PUBLIC UTILITIES COMMISSION

RE: Sycamore – Peñasquitos 230-kV Transmission Line Project—Review of Minor Project Refinement #10 Request

Exhibit 1: MPR #10 Map

Attachment A: CPUC Evaluation of Minor Project Refinement #10

**SXPQ - Sycamore to Peñasquitos
230kV Transmission Line Project
MPR 10 Map 2: Proposed Refinement &
Approved Overhead Options 1 and 2**

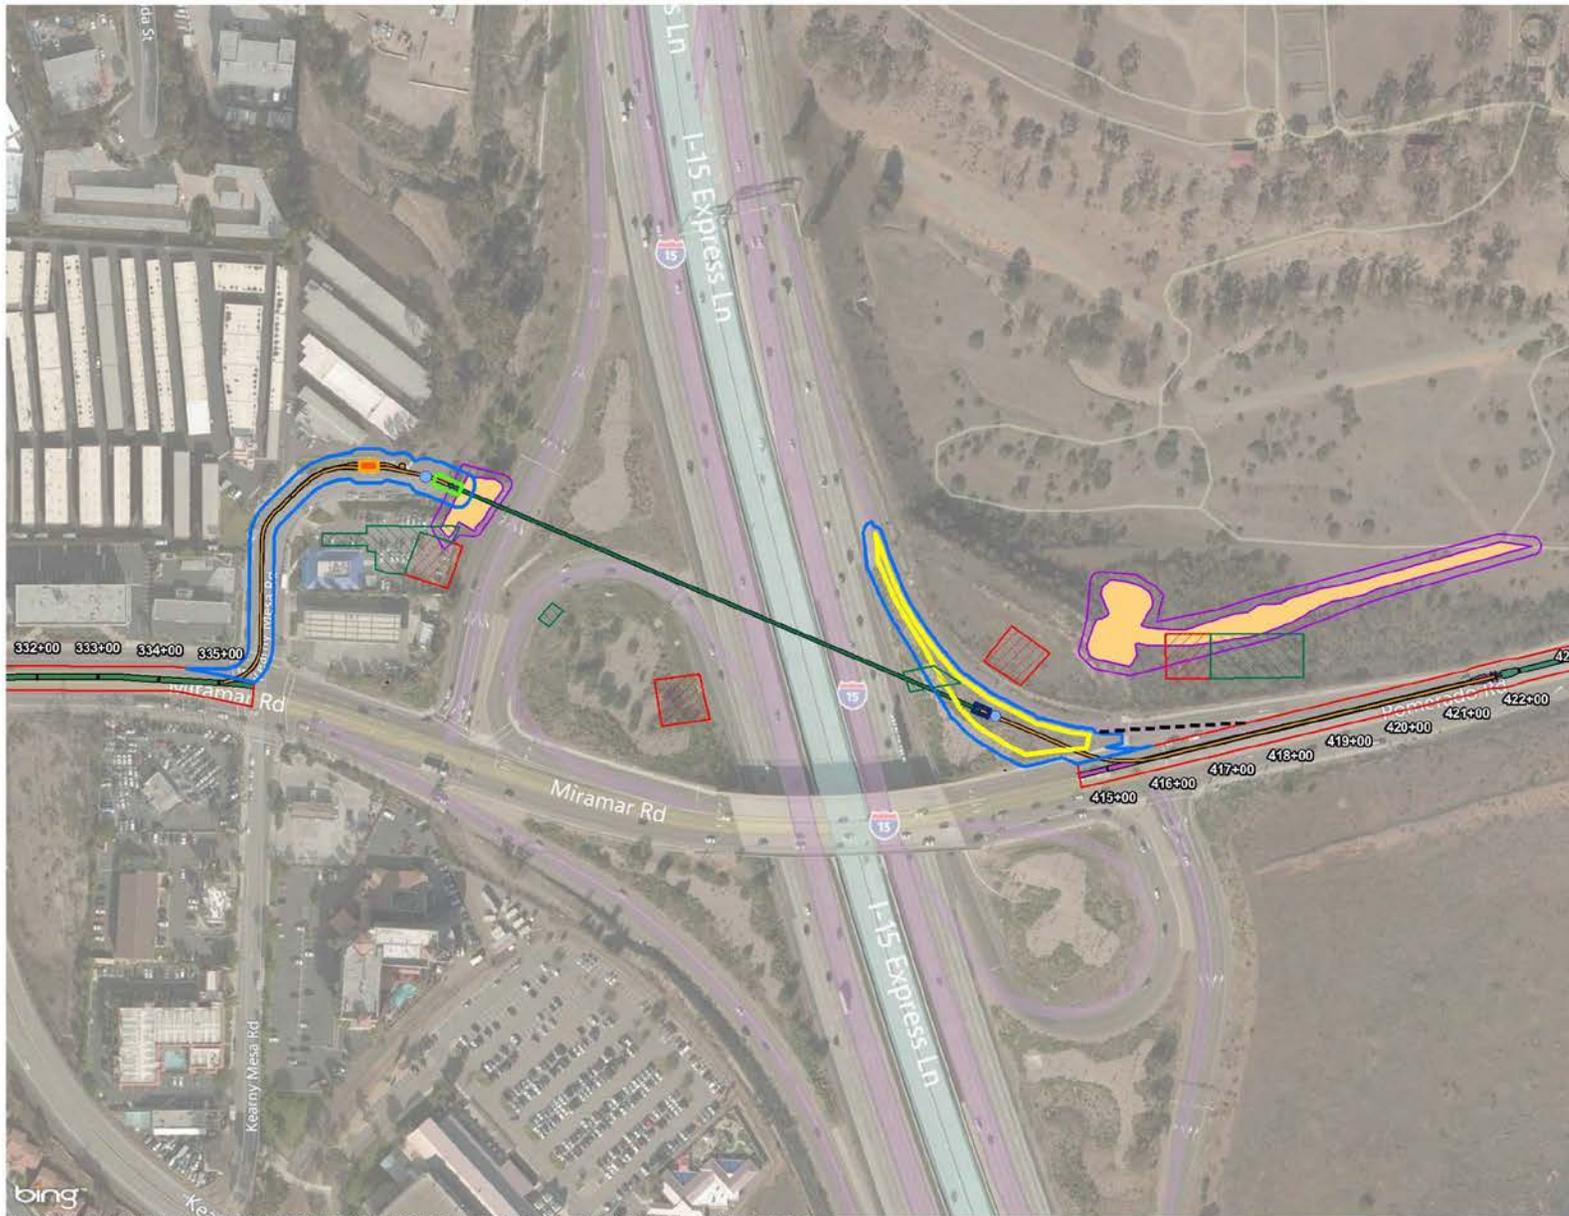
On November 29, 2017, SDG&E submitted Minor Project Refinement (MPR) #10 for approval by the California Public Utilities Commission (CPUC) for the Sycamore-Peñasquitos 230-kV Transmission Line Project (Project). MPR #10 authorizes a newly identified underground route option for the crossing of Interstate (I)-15, using a tunnel bore machine (TBM) to install the 230 kilovolt (kV) line under I-15, as shown in Exhibit 1 (attached).

This refinement proposes an underground alternative to cross I-15. Under this refinement a TBM (a remotely controlled laser-guided steerable trenchless machine) would be used to install a reinforced concrete pipe (RCP) that would house the transmission line underneath I-15. The underground tunnel would be approximately 1,000 feet long and would extend from the western temporary work area located just south of the I-15 southbound exit ramp to Miramar Road to the eastern temporary work area located just south of the I-15 northbound on-ramp off of Pomerado Road.

The western temporary work area would be located at the eastern end of the Kearny Mesa Road cul-de-sac (extending slightly into the ornamental/developed area) located west of the I-15 southbound exit ramp to Miramar Road, and would extend to the intersection of Kearny Mesa Road and Miramar Road. The western temporary work area would be approximately 0.68 acre. Within the western temporary work area, a bore (sending) pit would be excavated at approximately station 403+50 and would measure approximately 12 feet wide by 40 feet long and have a maximum depth of 31 feet. The western temporary work area would also include a new proposed vault location (relocated from Miramar Road west of Kearny Mesa Road) at station 402+00 on Kearny Mesa Road. In addition, the western temporary work area would include a 3-foot-wide trench that would be approximately 640 feet long and would extend from the eastern side of the bore (sending) pit to the new proposed vault at station 402+00 and continue to then connect to the approved underground portion of the existing Project at station 335+00 on Miramar Road. The western temporary work area would include space for the TBM, the bore (sending) pit, and trucks to transport spoils. The bore (sending) pit would be protected by steel shoring. The western temporary work area would be accessed from Miramar Road, which mirrors access for the overhead crossing options identified in the FEIR.

The eastern temporary work area is approximately 0.76 acre and would be located within the ornamental/developed area located west of the I-15 northbound on-ramp off Pomerado Road and east of the I-15 northbound lanes. Within the temporary work area, a graded pad would be constructed and would measure approximately 50 feet wide by 300 feet long, and would be approximately 0.33 acre. Within the graded pad, a receiving pit would be excavated at station 412+50, which would measure approximately 12 feet wide by 25 feet long and have a maximum depth of 42 feet. The receiving pit would be protected by steel shoring. The eastern temporary work area would also include a 3-foot-wide trench that would be approximately 322 feet long and would extend from the western side of the receiving pit and intercept the existing trench alignment at station 415+50 on Pomerado Road and continue to the vault located at station 421+50. Access to the eastern temporary work area would be obtained via the I-15 northbound on-ramp from Pomerado Road (Attachment 1). All construction equipment would utilize the on-ramp to access the work area. All temporary work areas, including the graded pad, will be restored to pre-project conditions.

Construction activities associated with the proposed refinement would include trenching, excavation and exportation of spoils, grading, shoring, and bore operation. The boring operation would begin at the western bore (sending) pit where the TBM would be remotely guided southeast under I-15 and connect to the receiving pit east of I-15. The total length of the underground tunnel would be approximately 1,000 feet. At its maximum depth below ground

level, the underground tunnel would reach a depth of approximately 42 feet, with the minimum depth being approximately 15 feet.

MPR #10 is approved by the CPUC with conditions. The conditions presented below shall be met by SDG&E and its contractors:

1. All applicable Project MMs, APMs, compliance plans, and permit conditions shall be implemented. Some measures have on-going/time-sensitive requirements and shall be implemented prior to and during construction, where applicable. Prior to construction, SDG&E must submit all applicable permits to the CPUC.

4. SDG&E shall implement appropriate dust controls at the MPR #10 work areas in accordance with the approved Dust Control Management Plan, and SWPPP. SDG&E shall use non-potable water for dust control, as required by MM Utilities-1.

5. SDG&E shall implement all appropriate erosion and sediment control BMPs for the MPR #10 work areas as defined in the SWPPP, and as specified by the Qualified SWPPP Practitioner. Sediment and

6. All ground-disturbing activities (e.g., grading, trenching, etc.) shall be monitored by a CPUC-approved archaeological monitor and a Native American monitor in accordance with MM Cultural Resources-1, where appropriate. In the event of an archaeological discovery, all construction activity associated with MPR #10 shall be halted.

7. All ground-disturbing activities at the MPR #10 work areas shall be monitored by a CPUC-approved paleontological monitor. In the event of a paleontological discovery, all earthwork must cease within 50 feet of the discovery, and procedures defined in MM Paleontology-3 shall be implemented.
